**STAFF REPORT
(One-Step Preliminary-Final Plat)**

CASE NUMBER: S/D 97-43 VOEGELI ADDITION

STAFF REPORT
(One-Step Final Plat)

CASE NUMBER: SUB 2004-28 -- VOEGELI ADDITION

VICINITY MAP

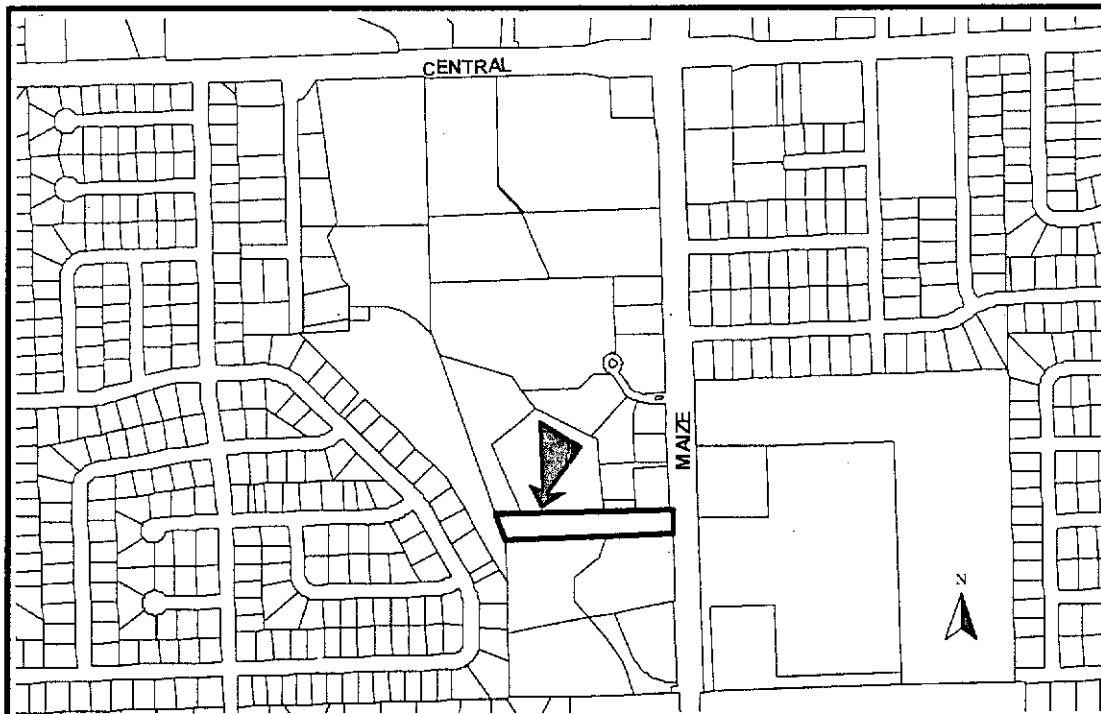
- L. The vicinity map needs corrected to replace Kellogg with Maple.
- M. The platting text shall include language that a drainage plan has been developed for the plat and that all drainage easements, rights-of-way, or reserves shall remain at established grades or as modified with the approval of the applicable City or County Engineer, and unobstructed to allow for the conveyance of stormwater.
